# **Los Alamos and Pueblo Canyons Work Plan Addendum**

## **Surface Water and Alluvial Groundwater Sampling and Analysis Plan**

Produced by the Canyons Focus Area

Figure 7-14. Los Alamos and Pueblo Canyons surface water, alluvial groundwater, and spring monitoring locations

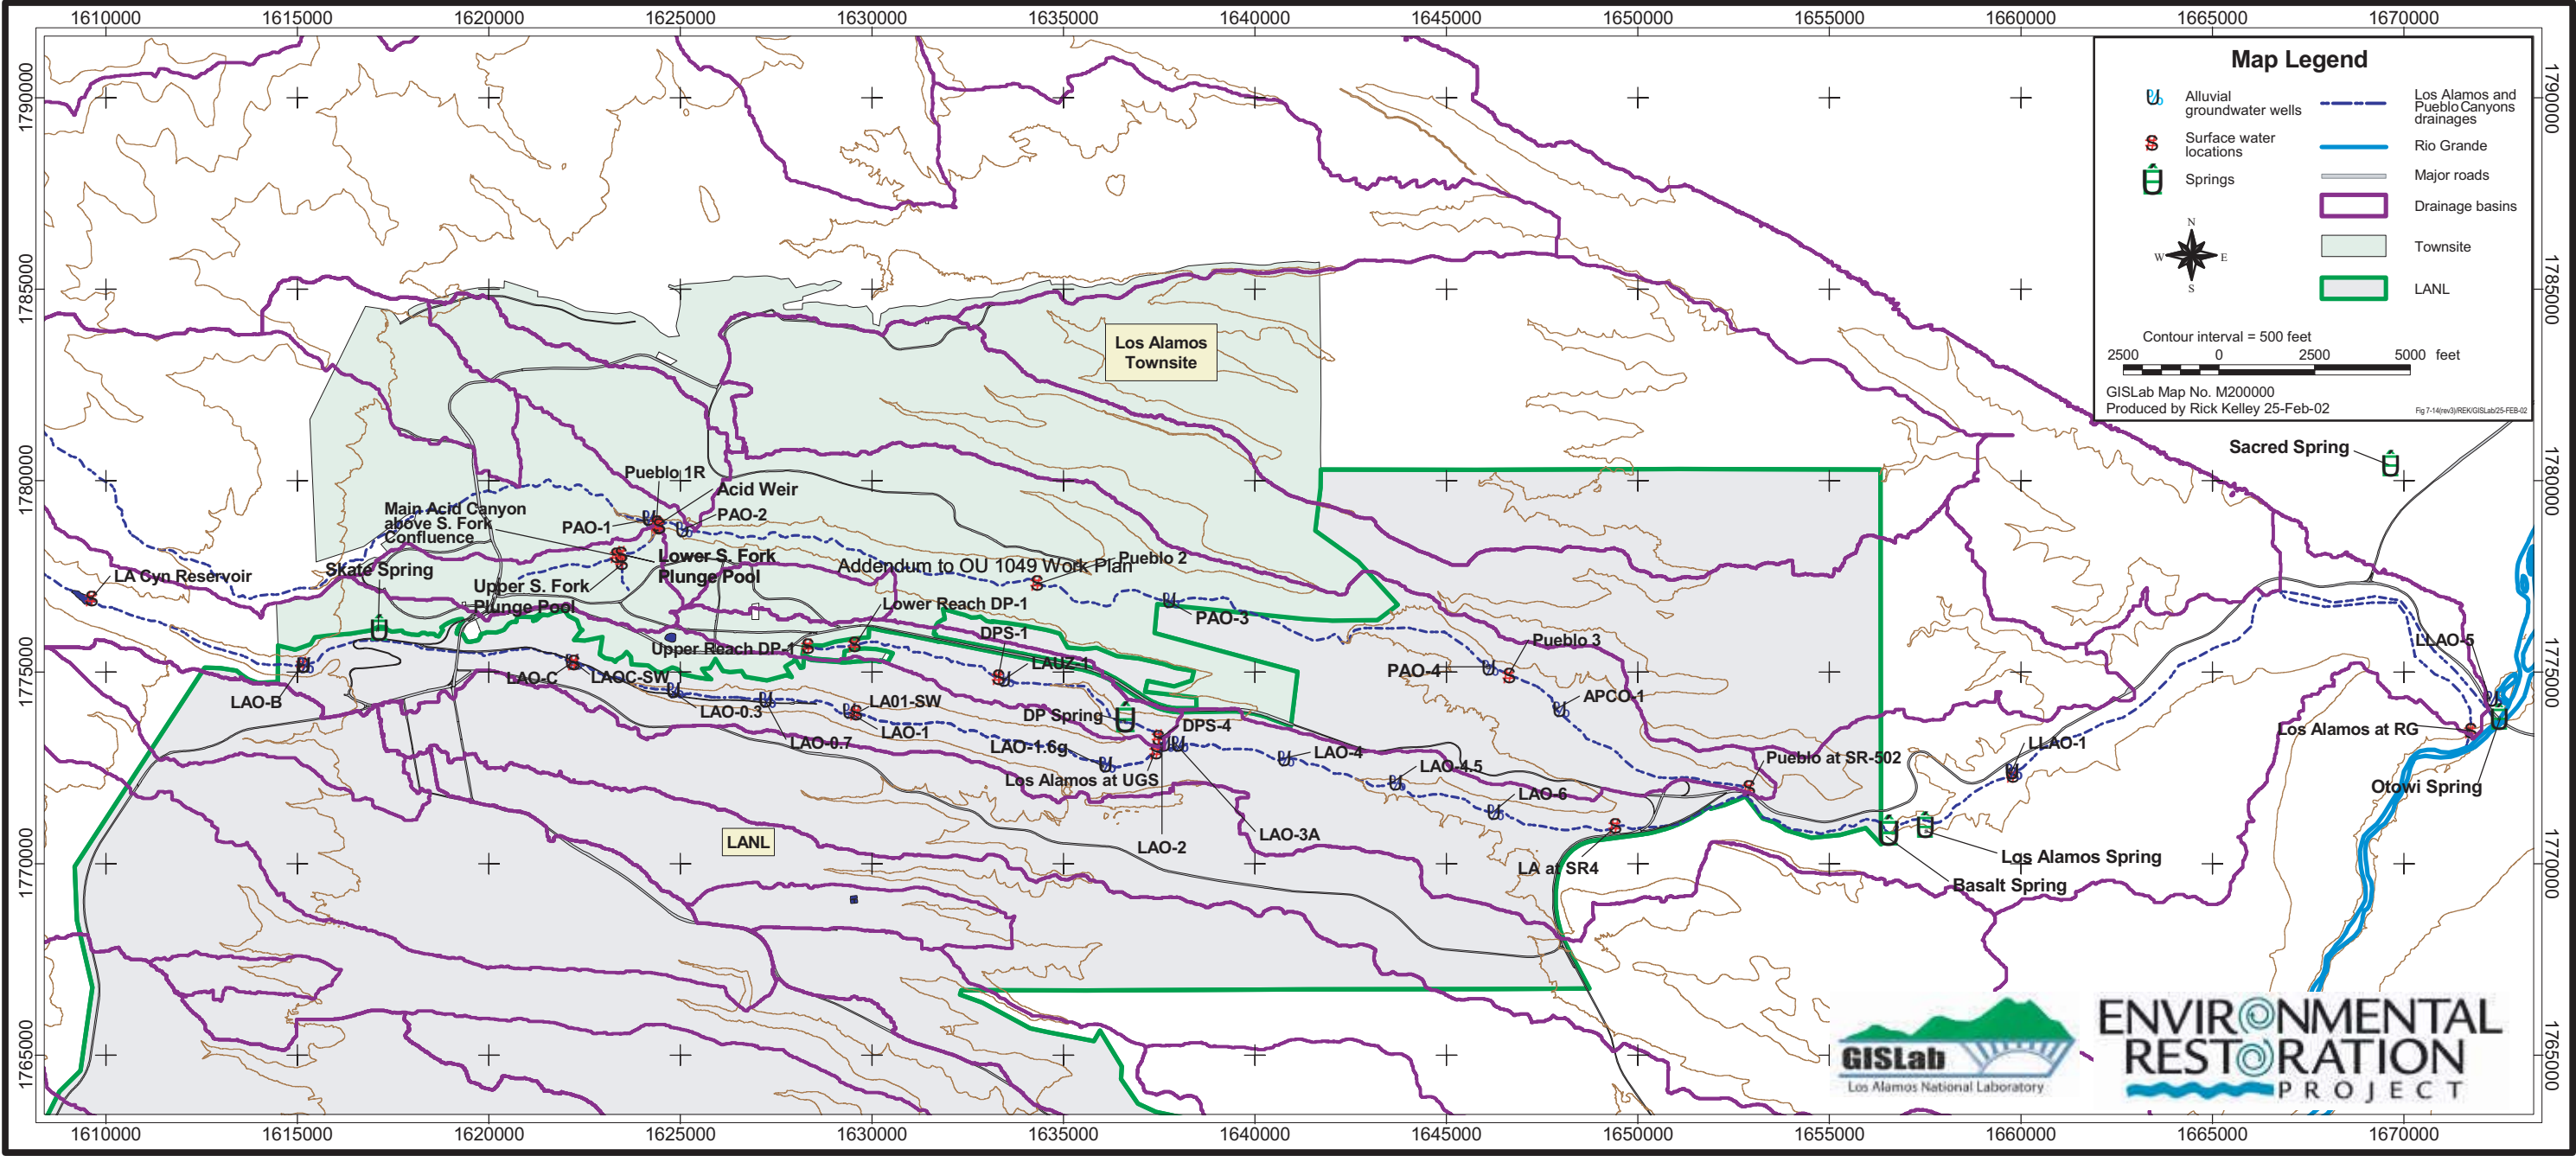
Figure 7-14, Proposed Well Locations: western Los Alamos and Pueblo Canyons	Figure 7-14, Los Alamos and Pueblo Canyons Surface Water, Alluvial Groundwater, and Spring Monitoring Locations
Figure 7-15, Proposed Well Locations: central Los Alamos and Pueblo Canyons	Figure 7-14, Los Alamos and Pueblo Canyons Surface Water, Alluvial Groundwater, and Spring Monitoring Locations
Figure 7-16, Proposed Well Locations: eastern Los Alamos and Pueblo Canyons	Figure 7-14, Los Alamos and Pueblo Canyons Surface Water, Alluvial Groundwater, and Spring Monitoring Locations

coverage of shallow alluvial water and their past performance as monitoring points. Selections of surface water and alluvial groundwater sampling locations were biased towards the presence of contamination and the spatial bracketing of contaminant sources. Table 7-11 (revised), Description of Monitoring Locations and Rationale for Alluvial Groundwater and Surface Water, provides the location description and rationale for each monitoring point. Figure 7-14 (revised), Los Alamos and Pueblo Canyons Surface Water, Alluvial Groundwater, and Spring Monitoring Locations, shows the locations of the monitoring points.
